DEVELOPMENT CONTROL PANEL

4 December 2019

Item: 6

Application No.:	19/01701/FULL
Location:	Sandridge House Including The Cottage And The Bungalow London Road Ascot
Proposal:	33 No. dwellings, with associated parking and landscaping following demolition of existing buildings.
Applicant:	Patrick Homes Limited
Agent:	Mr Matt Hill
Parish/Ward:	Sunninghill And Ascot Parish/Ascot & Sunninghill

PROPOSED SITE PLAN

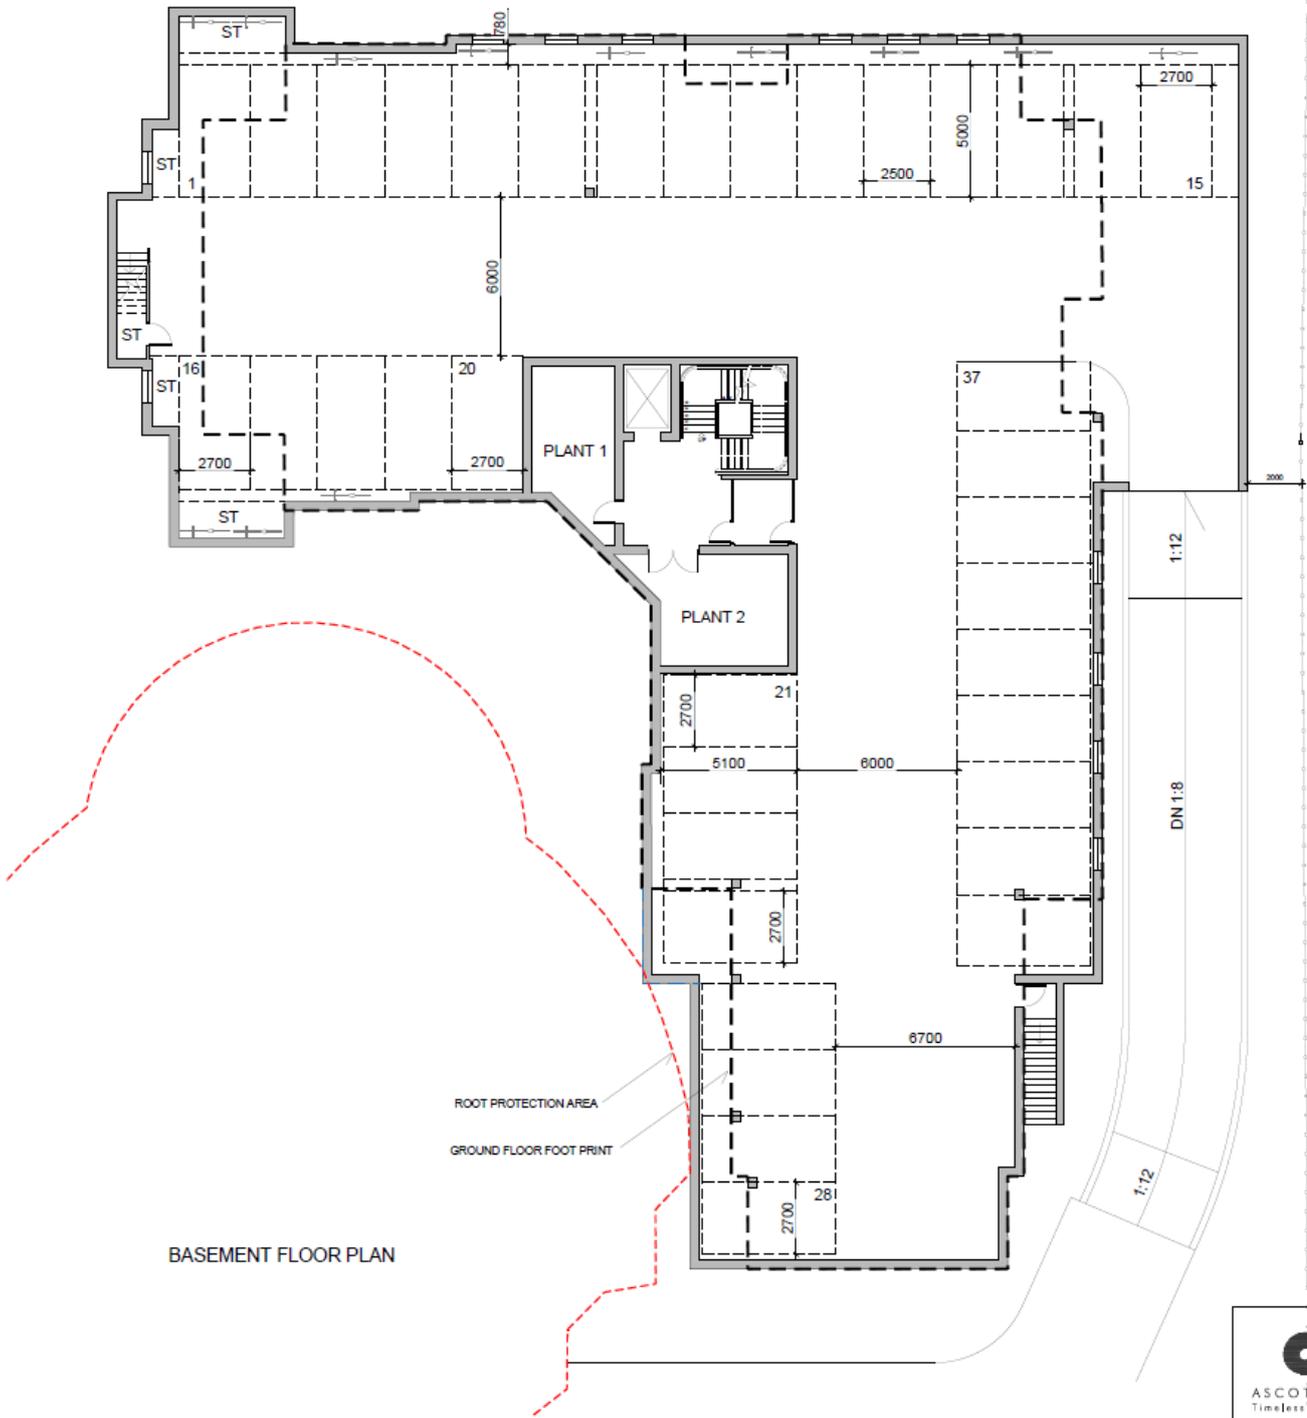
- 9.27 In addition to the above, the design of the new entrance should ensure that the proposed gates are positioned at least 5.0m from the highway boundary, or 7.0m from the kerb edge to allow a car to be driven off the public highway before the gates are opened. The position of the gates indicated the *Proposed Site Plan [18-J2556-01]* do not satisfy this requirement.

- 9.38 The proposed site plan 18-J2556-01 shows the existing hedge/tree screening belts along the partial length of boundaries to be replaced with new planting. It is unnecessary to remove existing where these are of reasonable quality.

- 9.28 Overall the site access arrangement is considered acceptable. However, the applicant is required to submit an amended plan for the gated entrance and speed survey details. It is considered that were the application being recommended for approval the submission of these details could have been left to condition.

CYCLE STORE PLAN

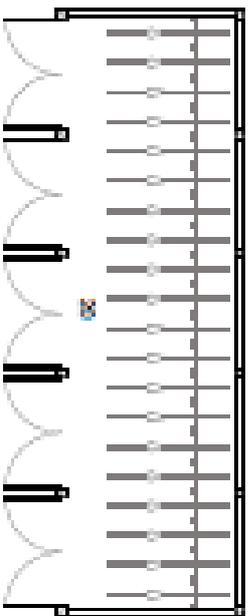
- 9.32 The internal width of the store is too narrow to accommodate 20 cycles. The stands which is presumed to be a Sheffield-type format should be at least 900mm apart. The applicant is advised that ramps designed for cycle and vehicle use should employ measures to reduce vehicle speeds and prioritise safety (e.g., barrier access). Furthermore, the gradient of ramped access for cyclists should not exceed 1:12. The applicant is required to amend the plans and provide the supporting information which has informed the cycle parking design for the development. The design and accessibility to the individual cycle store should also be reviewed. These details could be provided via condition if the application were to be approved.
